Re: Minor Project Refinement No. 16 for the TL 6975 San Marcos to Escondido Project

TL6975 San Marcos to Escondido 69 kV Project CPUC Minor Project Refinement Form

ATTACHMENT B
MPR-16 Figure

**MPR 16
Additional Work Areas
San Diego County, CA**

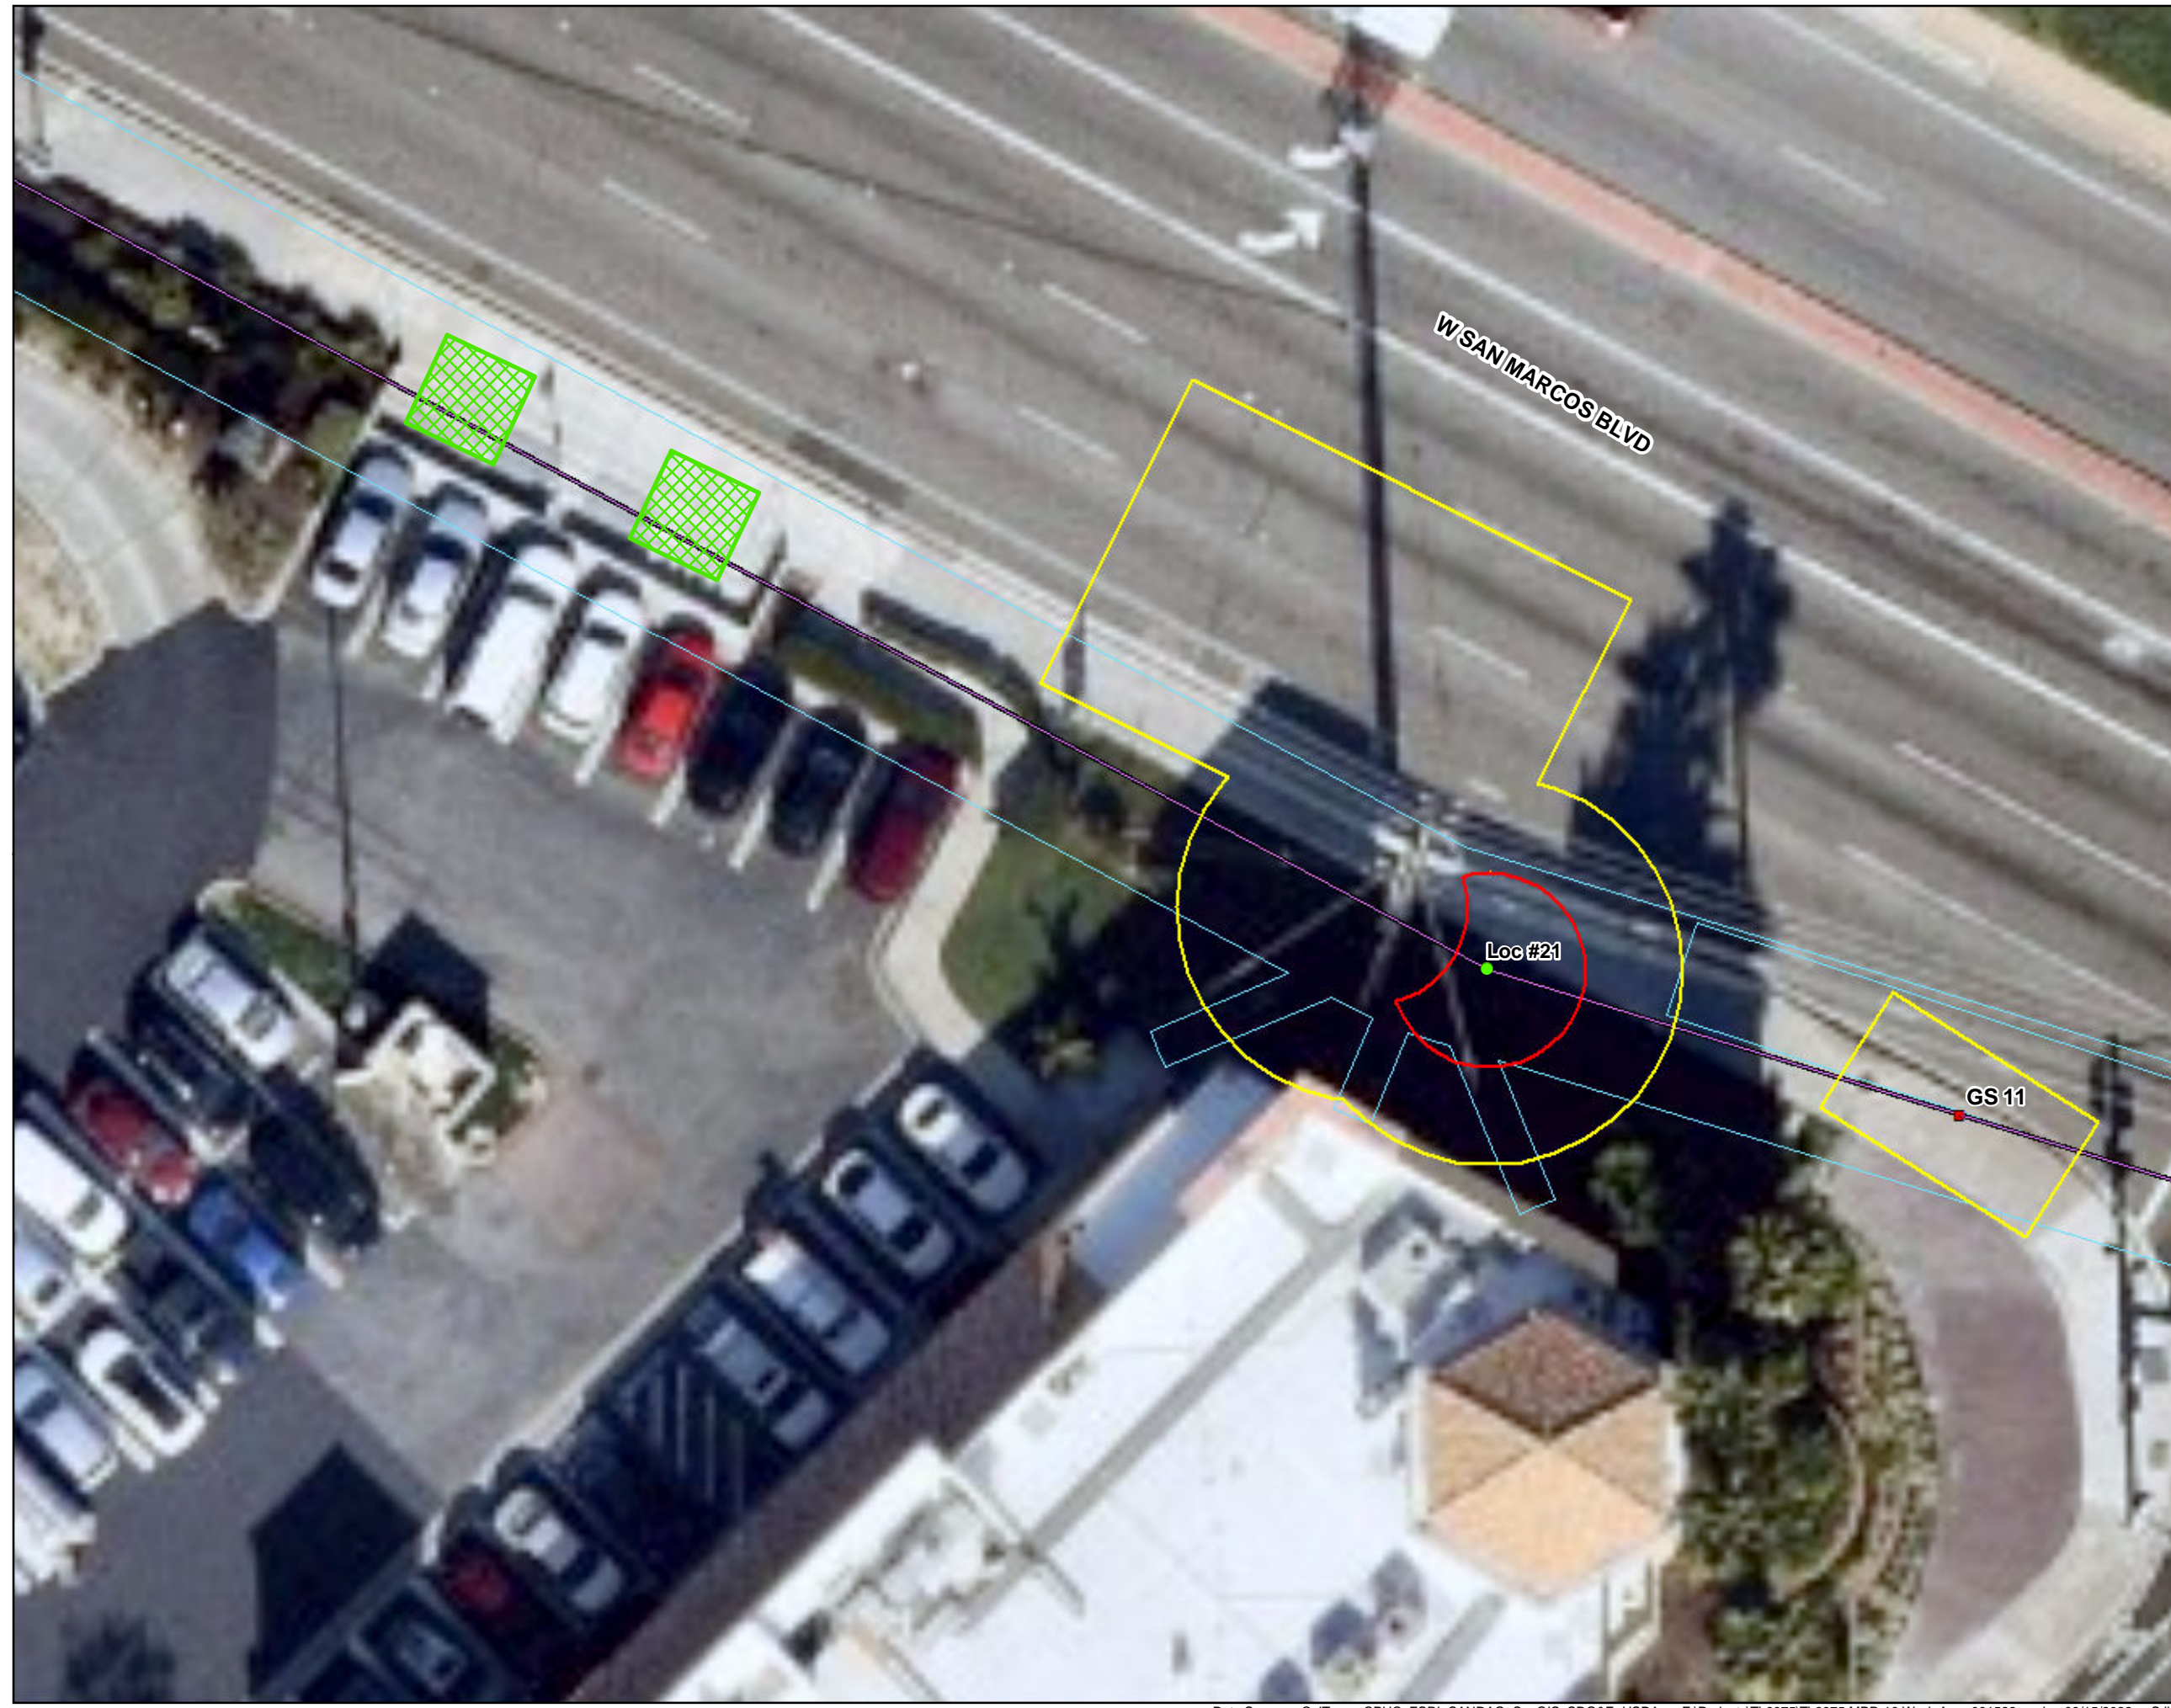
San Diego Gas and Electric (SDG&E) is requesting approval of MPR-16 to place two concrete anchor blocks per site at Locations 20 and 21 to support wire stringing activities in Segment 1 of the TL6975 San Marcos to Escondido Project (Project). See **Attachment B, MPR-16 Figure** and **Attachment C, MPR-16 Site Photographs**, for an overview of the proposed MPR-16 work areas.

SDG&E has identified two 10-foot by 10-foot work areas at Locations 20 and 21 where two 8-foot by 8-foot concrete anchor blocks would be placed per site adjacent to the approved work areas (see **Attachments B and C**). Anchors will be installed on top of each concrete block and guy wires will attach the top of the pole (i.e., Location 20 and 21) to the anchor blocks to stabilize the pole during wire stringing activities. If the new foundation at Location 21 passes inspection, the anchor blocks would only be utilized at Location 21 to achieve adequate tension on the pole during the wire pull from Location 8 to Location 21 scheduled for September 28. If the foundation is not quite cured and
